NPF-10/15-449
Supplement 1

ATTACHMENT "A"

Original PCN 449

UNIT 2

FIGURE 3.7.18-1

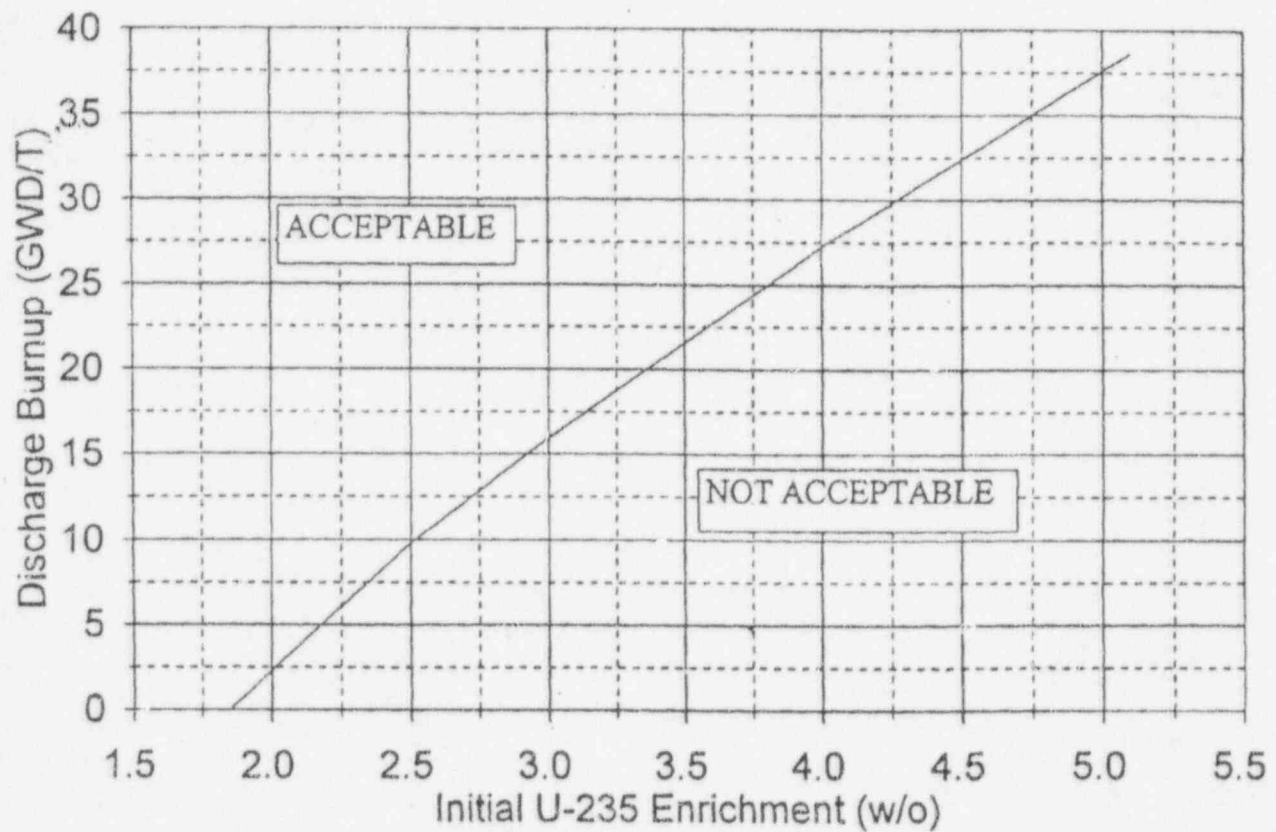
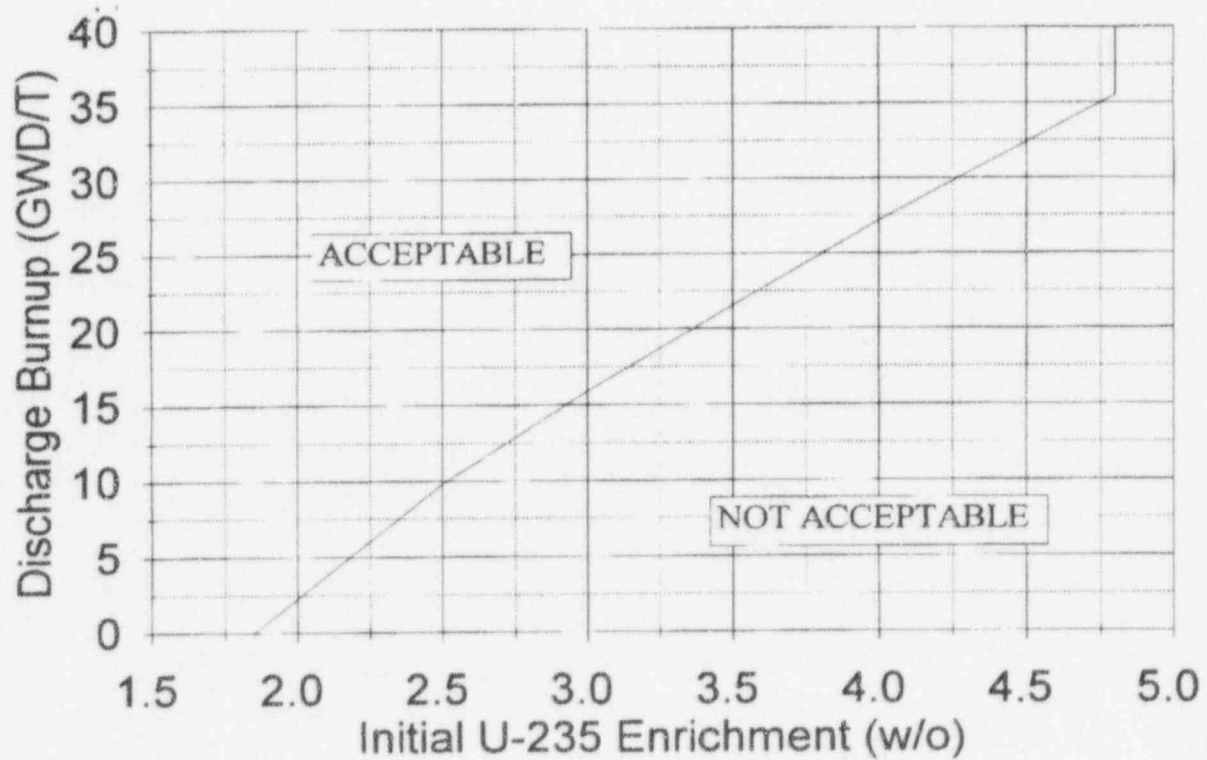
MINIMUM BURNUP VS INITIAL ENRICHMENT FOR UNRESTRICTED
PLACEMENT OF SONGS 2 AND 3 FUEL IN REGION II RACKS

MINIMUM BURNUP VS INITIAL ENRICHMENT FOR UNRESTRICTED
PLACEMENT OF SONGS 2 AND 3 FUEL IN REGION II RACKS

FIGURE 3.7.18-2

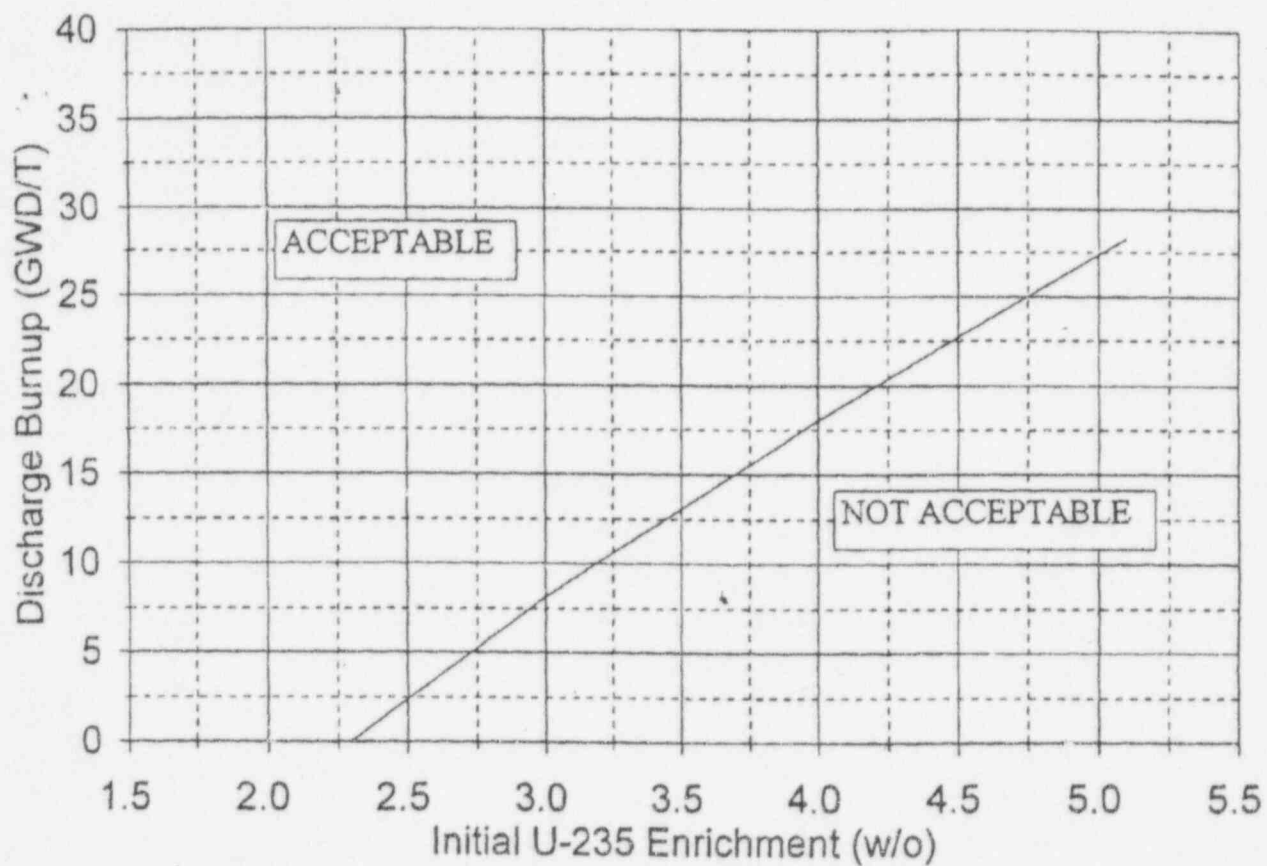
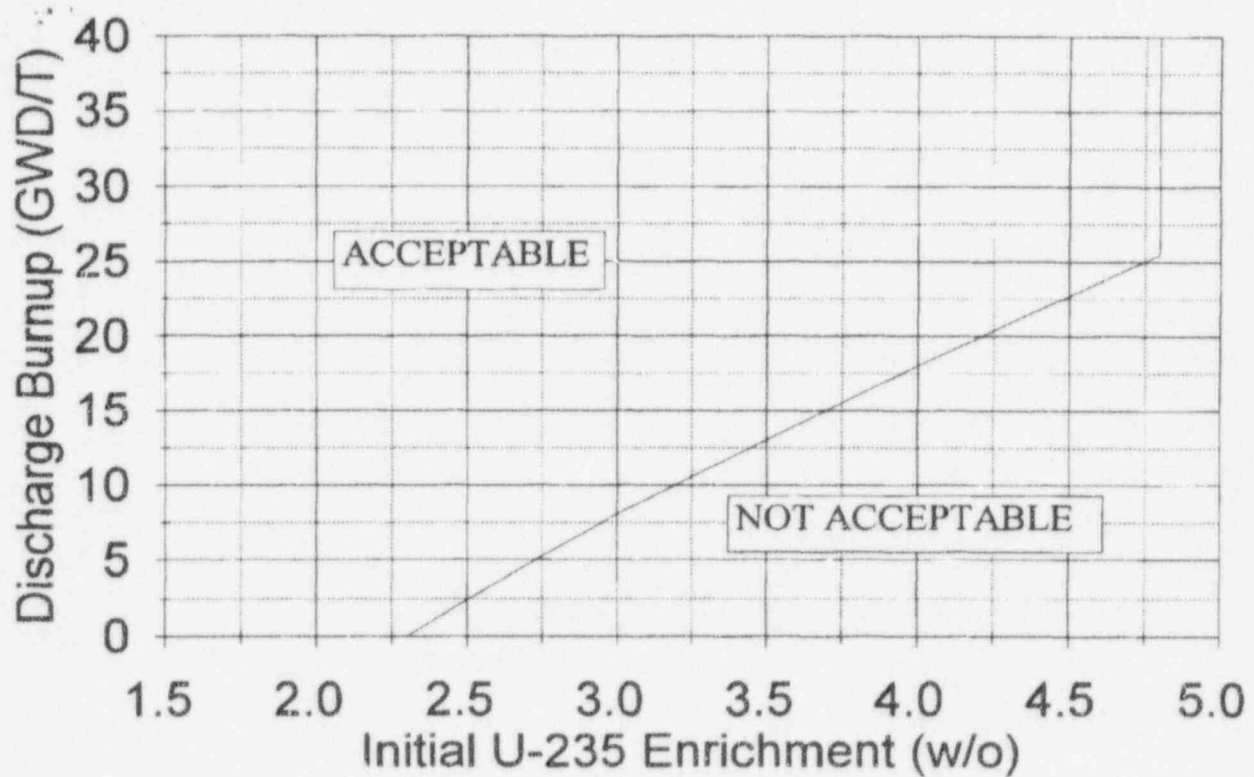
MINIMUM BURNUP VS INITIAL ENRICHMENT FOR PLACEMENT
OF SONGS 2 AND 3 FUEL IN REGION II PERIPHERAL POOL LOCATIONS

MINIMUM BURNUP VS INITIAL ENRICHMENT FOR PLACEMENT
OF SONGS 2 AND 3 FUEL IN REGION II PERIPHERAL POOL LOCATIONS
